April 30, 2008

Re: Draft North Coast Instream Flow Policy

**A Critical Review of the December 2007 State Water
Resources Control Board Draft Policy for Maintaining
Instream Flows in Northern California Coastal Streams and
Supporting Documents**

FIGURE 8-3
Project #15: Modeled impairment at POD#1 with no diversion constraints
All years

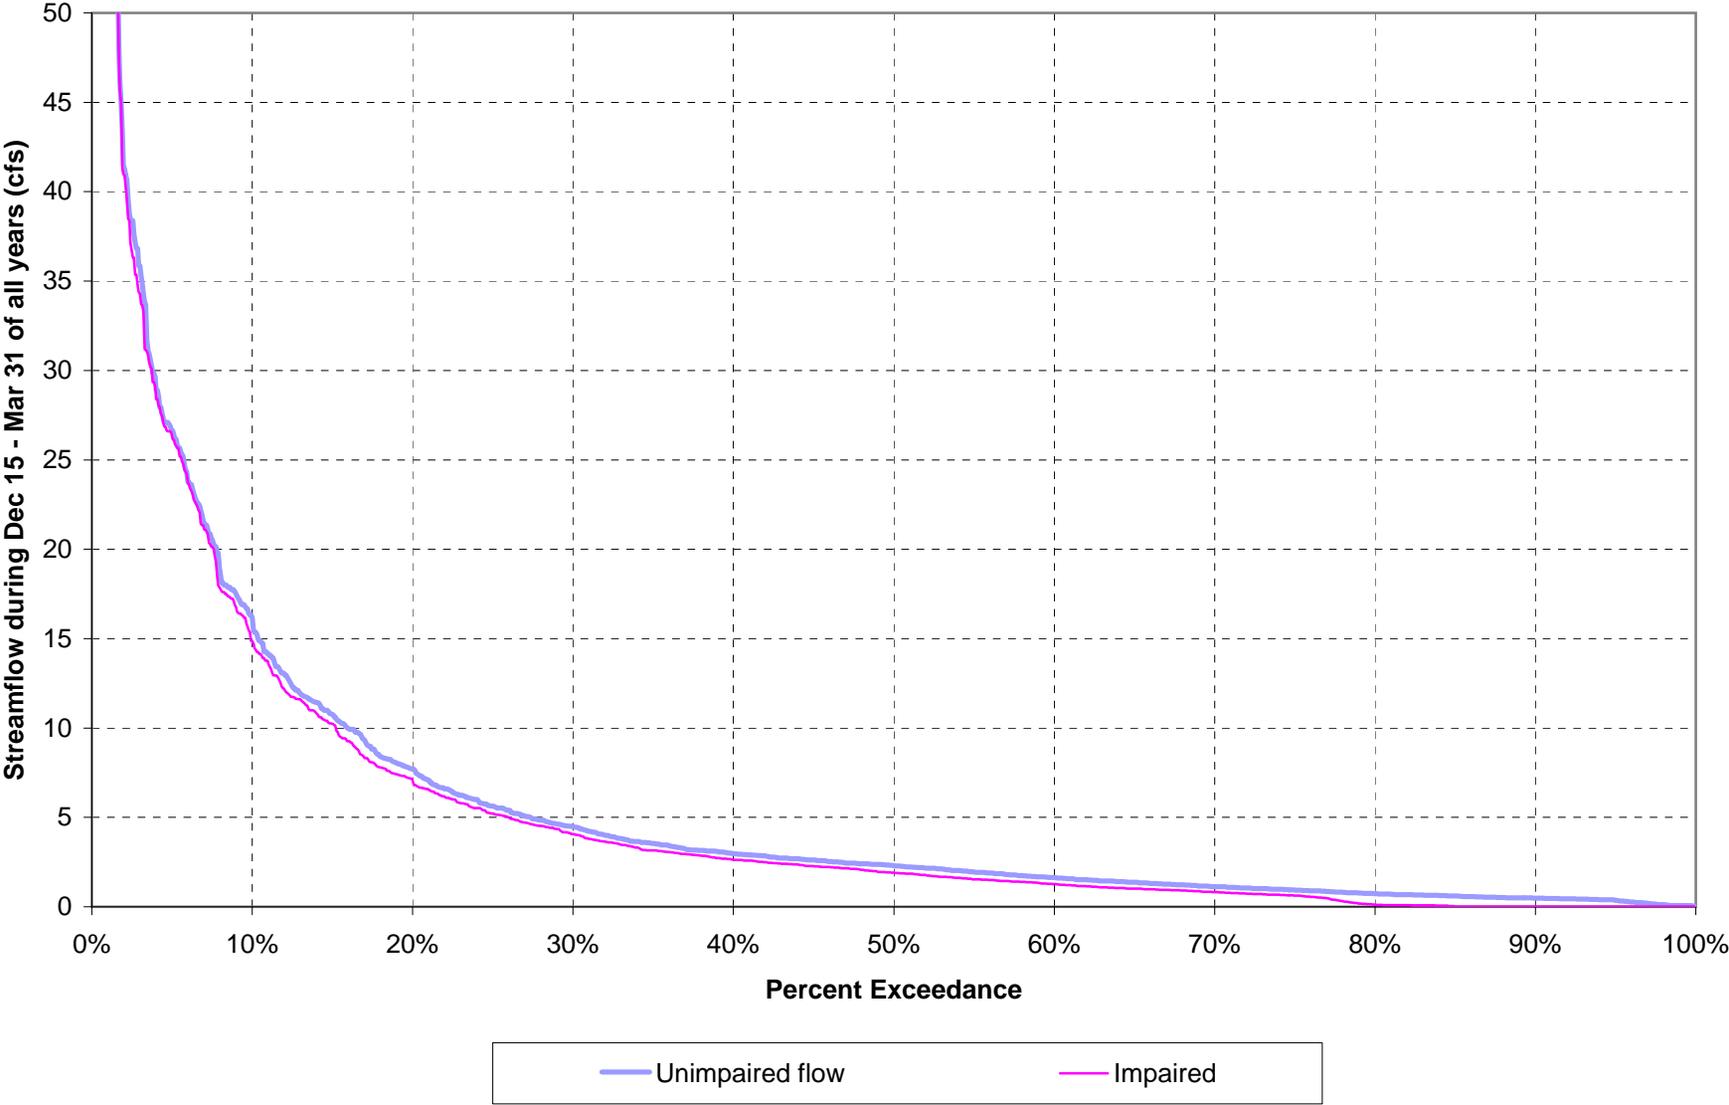
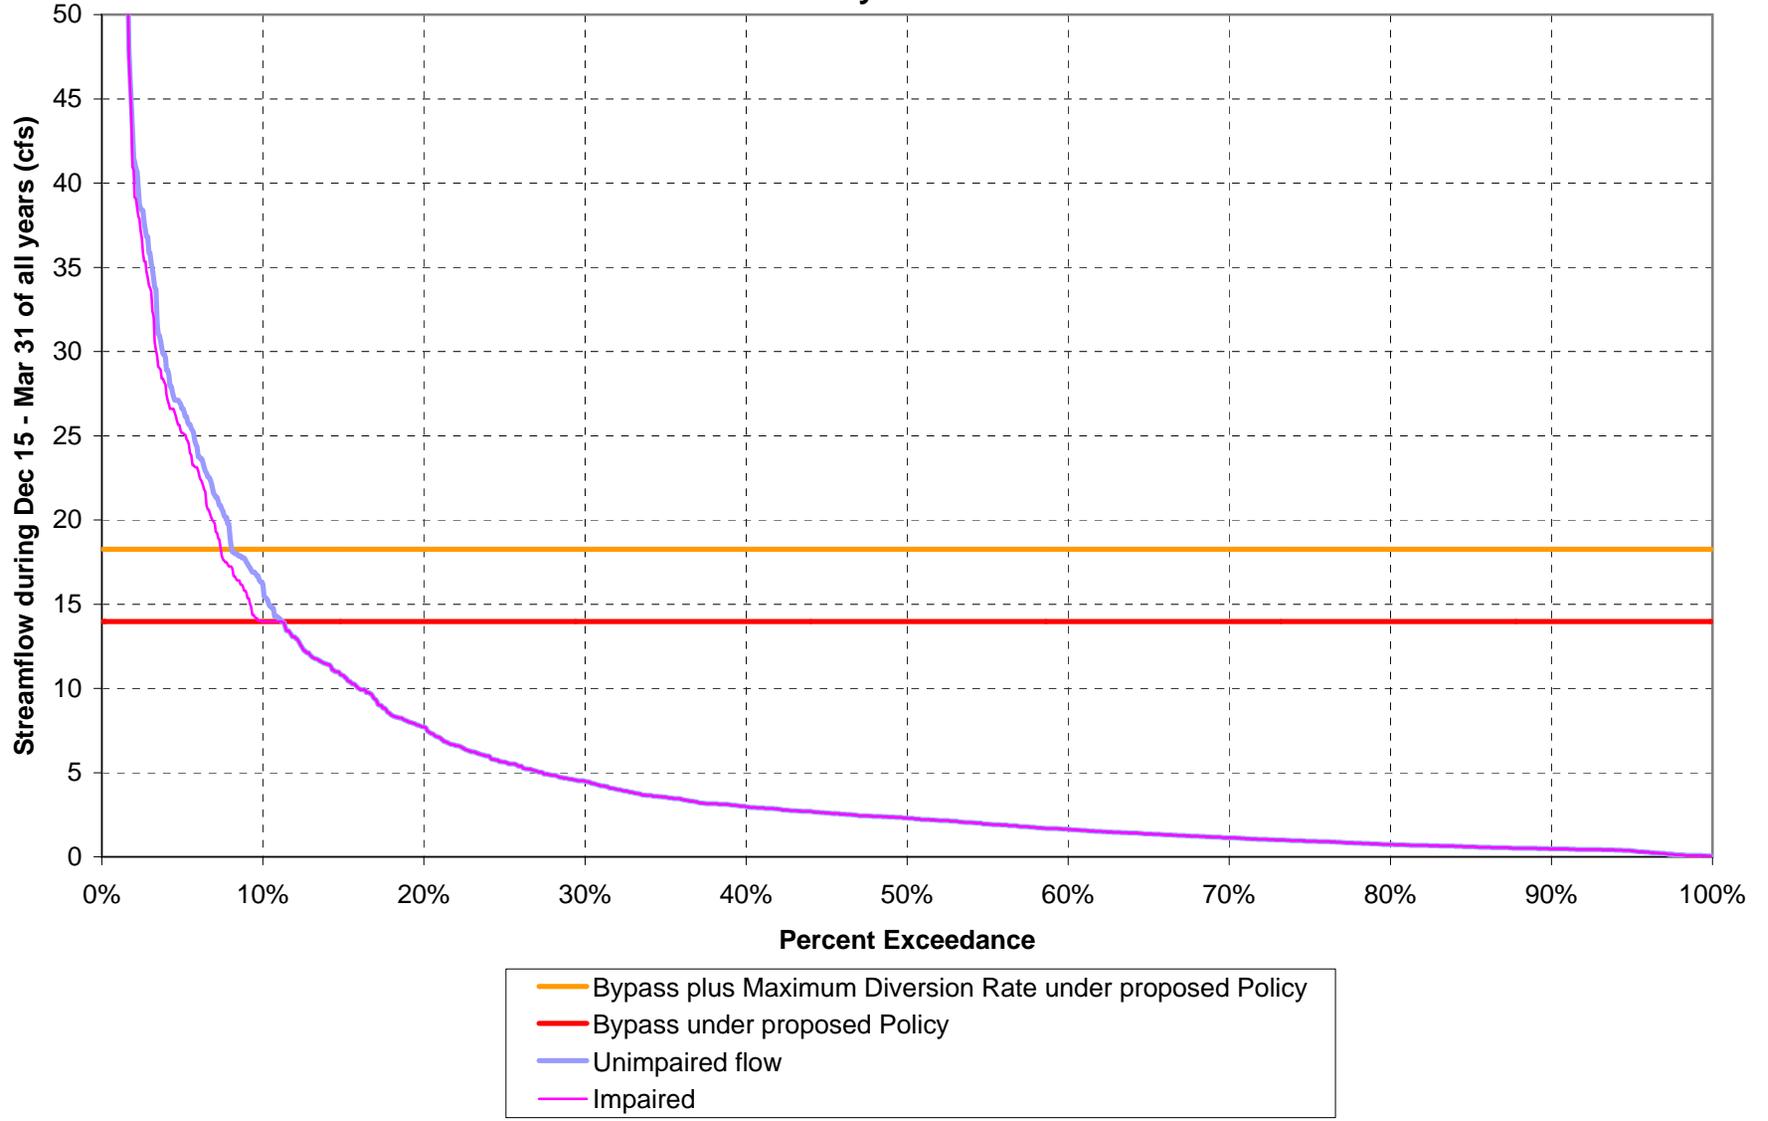
The exceedance curves shown in Figures 8-3 and 8-4 (attached) aggregate the unimpaired and impaired flows during the winter diversion season for all 15 years modeled for Project #15. Figure 8-3 shows the no diversion constraint scenario and Figure 8-4 shows the Policy scenario. The difference between the blue line and the thin red line reflects the change in streamflow due to the project.

Note in Figure 8-4 that the Policy minimum bypass requirement is met in unimpaired conditions only 11 percent of the time or about 12 days per year on average. That is, the project would be able to divert only 12 days per year, on average. That doesn’t mean that streamflows would be suitable for salmonids 12 days per year; high flow rates create high velocities that are unsuitable for spawning.
